# Access Compliance Report

## Public Rights-of-Way

### (Curb Ramps)

Intersection ID: N/A	Main Street: E 4TH ST	Cross Street: N/A	Location: N
ADA ID: 72D15438B043	Ramp Type: PerpDiag	Initial Pass/Fail: Fail	Overall Compliance: No
Severity Score: 22.5			
Codes/Mitigation Info/Possible Solution		Field Measurements/Component Compliance

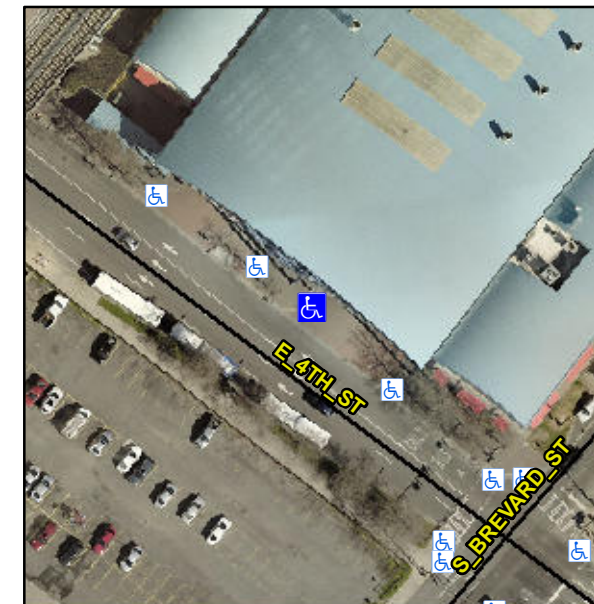
**Not Found, R304.5.1, R304.2.2**

Compliance	Description	Data	Compliance	Description	Data
N/A	Ramp Length (in)	70.0	No	Ramp Slope (%)	8.9
No	Ramp Width (in)	46.0	Yes	Ramp XSlope (%)	3.3
N/A	Flare Type LT	N/A	N/A	Flare Type RT	N/A
N/A	Flare Slope LT (%)	N/A	N/A	Flare Slope RT (%)	N/A
N/A	Flare Traversable LT?	No	N/A	Flare Traversable RT?	No
N/A	Landing Length (in)	N/A	N/A	DWS Provided?	N/A
N/A	Landing Width (in)	N/A	N/A	DWS Contrast?	N/A
N/A	Landing Slope (%)	N/A	N/A	DWS Length (in)	N/A
N/A	Landing X Slope (%)	N/A	N/A	DWS Full Width?	N/A
N/A	Landing Curb? (Y/N)	N/A	N/A	DWS Offset (in)	N/A
N/A	Shared Landing?	N/A			
N/A	Gutter Ponding?	N/A	N/A	Gutter Slope (%)	N/A
N/A	Gutter Lip Ht (in)	N/A	N/A	Gutter X Slope (%)	N/A
N/A	Painted X Walk1?	No	N/A	Painted X Walk2?	No
	X Walk 1 Direction	To SW		X Walk 2 Direction	To SE
N/A	X Walk 1 Width (in)	N/A	N/A	X Walk 2 Width (in)	N/A
	X Walk 1 Slope (%)	7.9		X Walk 2 Slope (%)	2.2
	X Walk 1 X Slope (%)	0.9		X Walk 2 X Slope (%)	7.3

**Remove & Replace Curb Ramp With Two New Directional Ramps or Equivalent.**
